Storm Runoff Calculations
Fenster Farm

Fenster Farm Subdivision Phase 3

Preliminary Design

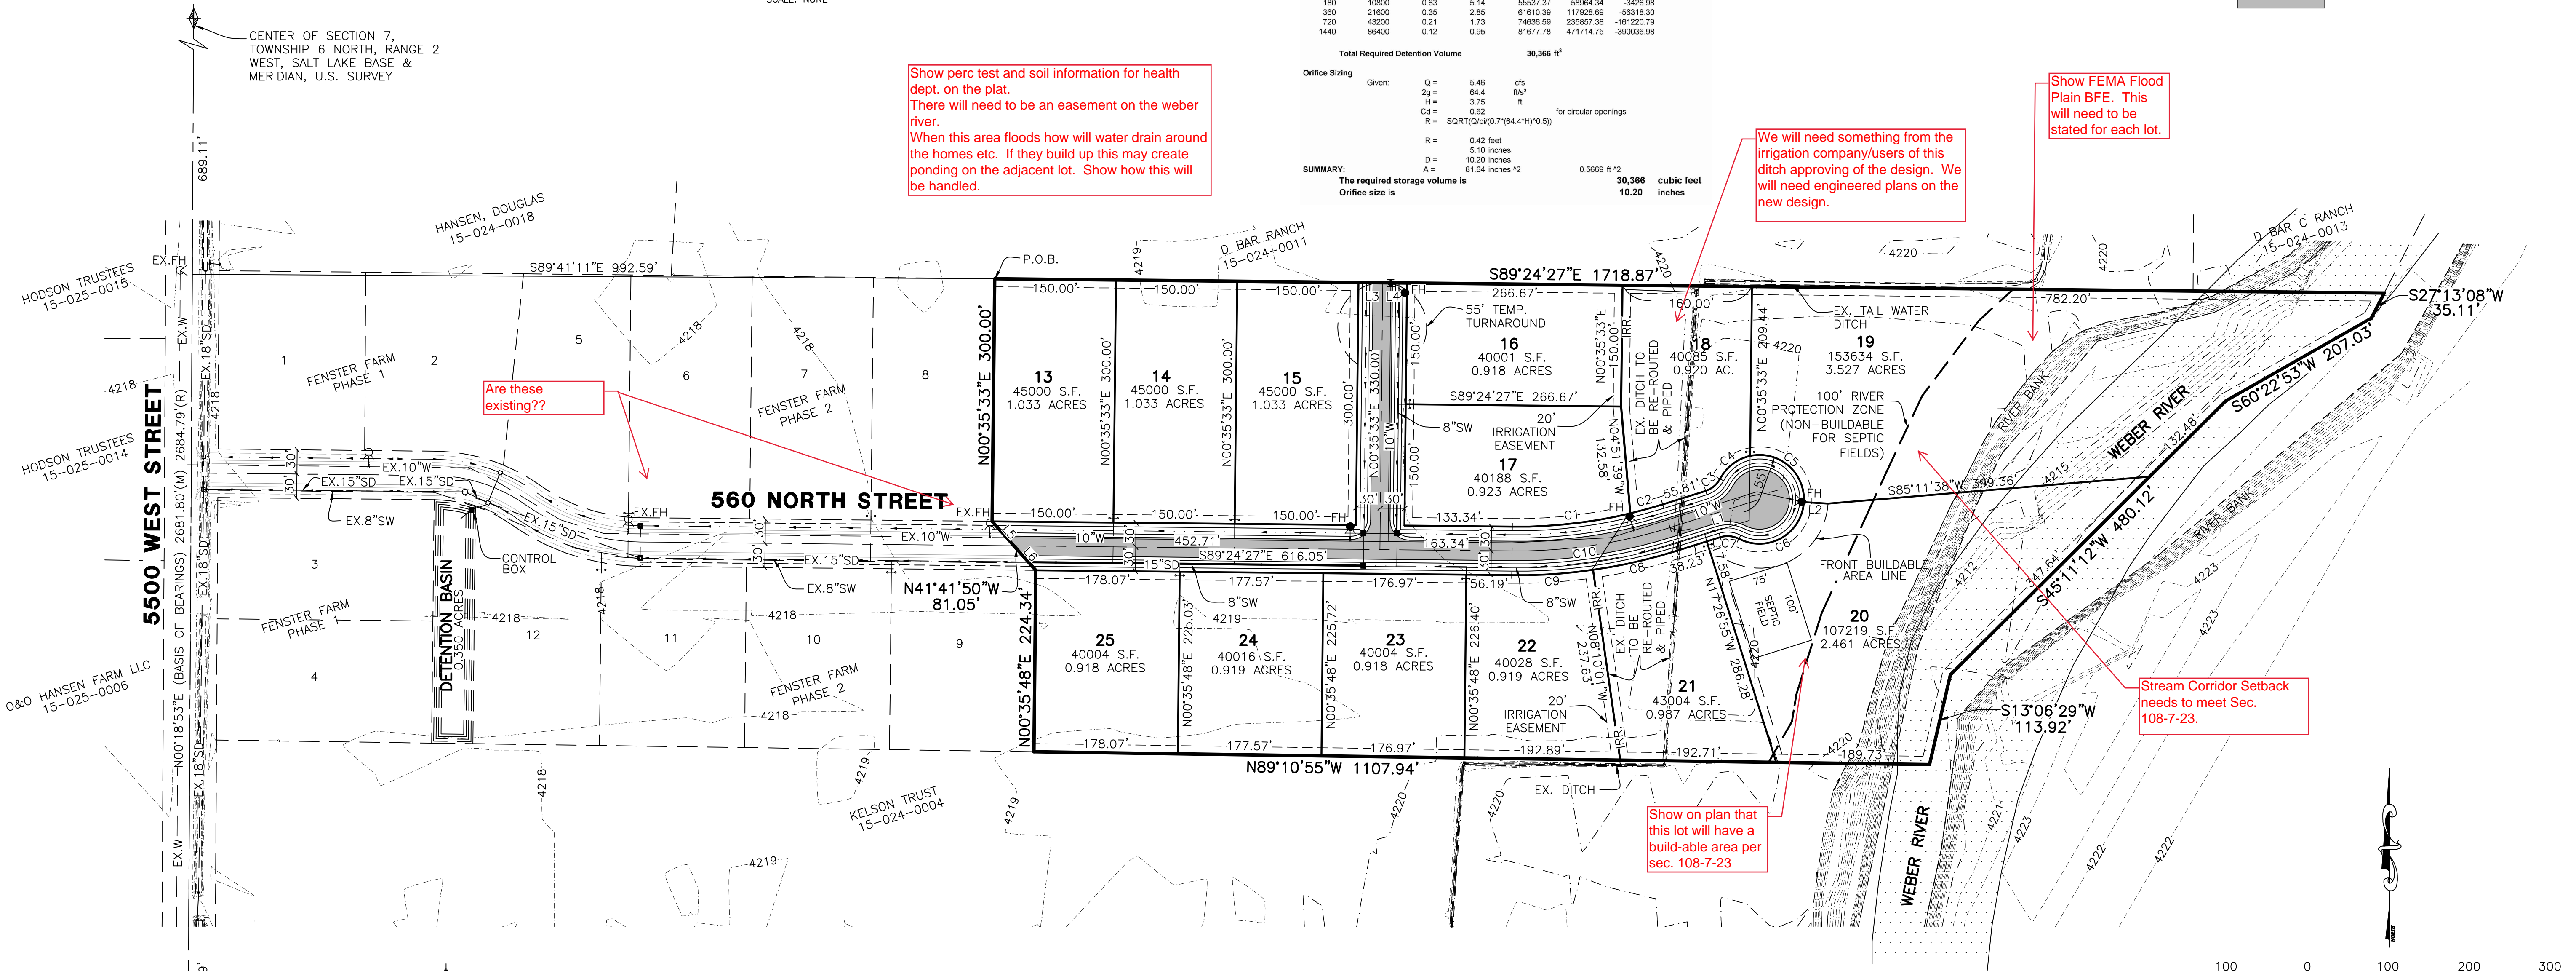
Are these existing??

Show perc test and soil information for health dept. on the plat.
There will need to be an easement on the weber river.
When this area floods how will water drain around the homes etc. If they build up this may create ponding on the adjacent lot. Show how this will be handled.

We will need something from the irrigation company/users of this ditch approving of the design. We will need engineered plans on the new design.

Show FEMA Flood Plain BFE. This will need to be stated for each lot.

Stream Corridor Setback needs to meet Sec. 108-7-23.

Show on plan that this lot will have a build-able area per sec. 108-7-23
